Submissions Report

Infill Affordable Housing

138 Maroubra Road, Maroubra

SSD-81426710

Table 2: Response to Randwick Council

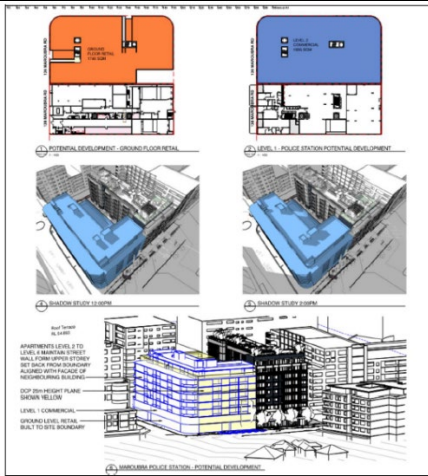
Item	Issue/ Comment	Proponent Response
Key Issues and areas of non-compliance		
Failure to Respond to Land and Environment Court Findings		
	Council is not satisfied that the amended scheme demonstrates that the previously identified impacts have been avoided or materially reduced. Instead, the increased height and scale indicate a strong likelihood that: • View loss will be equal or greater than previously identified; • Bulk and scale impacts will be intensified; and • The same unacceptable amenity outcomes will persist Accordingly, the proposal fails to meaningfully respond to the Court's findings and seeks to effectively reintroduce a development outcome that has already been found unacceptable on its merits.	• The proposed development complies with the height permitted under the Housing SEPP Chapter 2. The bulk and scale of the proposed development is compatible with the future desired character of the area as established by all of the relevant planning controls that apply to the site and surrounding area including the Low and Mid Rise Housing policy which applies to the residential zoned land in the surrounding area. Bulk, scale and desired future character is addressed in Section 8.2 of the EIS. • With regard to view loss, a View and Visual Impact Assessment (VVIA) was prepared with the EIS (Appendix P). The VVIA demonstrated that some surrounding residential dwellings will experience low or moderate view loss, however these views are inherently susceptible to change as they are obtained across common boundaries within a dense urban centre, and the proposed development is compliant with the maximum building height permitted at the site. The view impacts of the proposed development are therefore acceptable in a dense urban area where some level of change is anticipated by the planning controls that apply to the land. • With regard to amenity outcomes, the proposal provides reasonable amenity to existing neighbours and enables a future equitable development at the police station site. The proposed development is reasonably setback from existing neighbours, will facilitate future development of the police site and achieves reasonable amenity outcomes in a dense urban area undergoing change.

Table 3: Organisations Response to Submissions Table

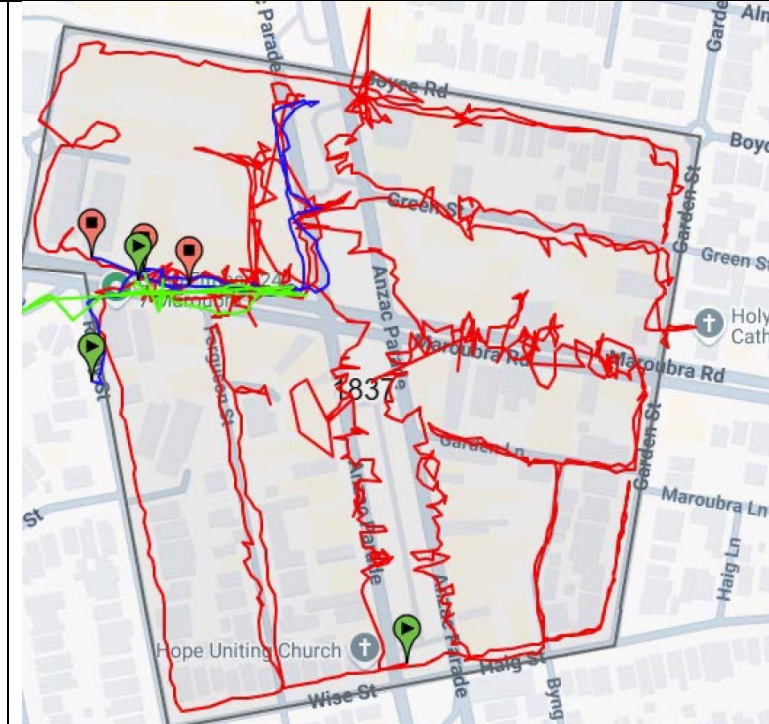
Issue/ Comment	Proponent Response
The proposed building exceeds local planning expectations for the area.	The proposed development complies with the permitted height under the Housing SEPP and is of a similar height, bulk and scale as other existing development along Maroubra Road and in the surrounding area.
There are insufficient setbacks and separation distances	The EIS and supporting documents have demonstrated that the objectives of the ADG setback controls relating to visual privacy and solar access have been met and that neighbouring dwellings are provided an adequate level of amenity. The proposed setbacks are an appropriate response on a narrow site and minimises impacts on neighbours.
The rooftop garden—with trees, structures and regular use— effectively adds another occupiable level	The rooftop communal open space is not an additional storey of the building and is open to the air.

Table 4: Public Submissions Response Table

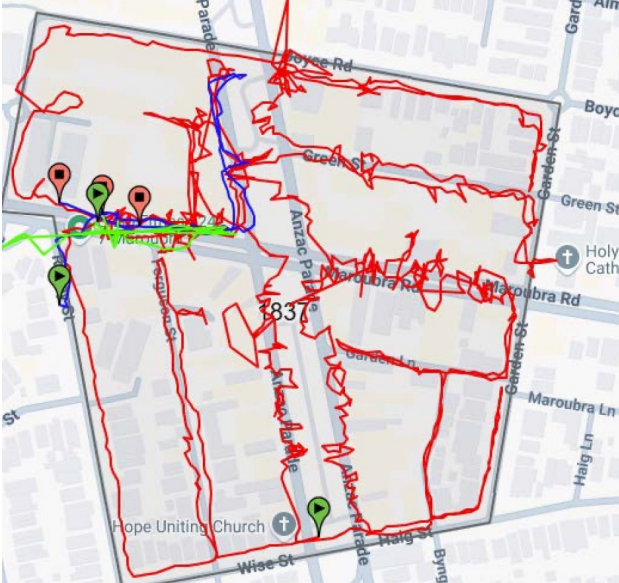
Number of submission mentions	Matter Raised	Response
42	Failure to Address LEC / SECPP Findings	
	The proponent has inadequately addressed the findings of the LEC and SECPP in relation to the previous DA.	The previous development application and LEC matter is addressed in detail in the EIS. Potential amenity impacts and view loss are addressed in detail in the EIS and supporting technical documents.
41	Contested Building Height / Height Non-Compliance	
	Concerns raised regarding the use of the 'Bettar' method to measure the height of building.	- The legal advice prepared by KL Gates concluded: – Its appropriate to measure building height consistent with the principles in Bettar v Council of the City of Sydney [2014] NSWLEC 1070 (Bettar) because adopting the methodology in Merman is not appropriate and would artificially exaggerate the height of the development when compared with height measured from an interpolated level which is consistent with that of the adjoining properties – and does not place the building in it's surrounding context. This is the approach taken in the SSDA. - This approach was accepted in the previous LEC and SECPP proceedings.
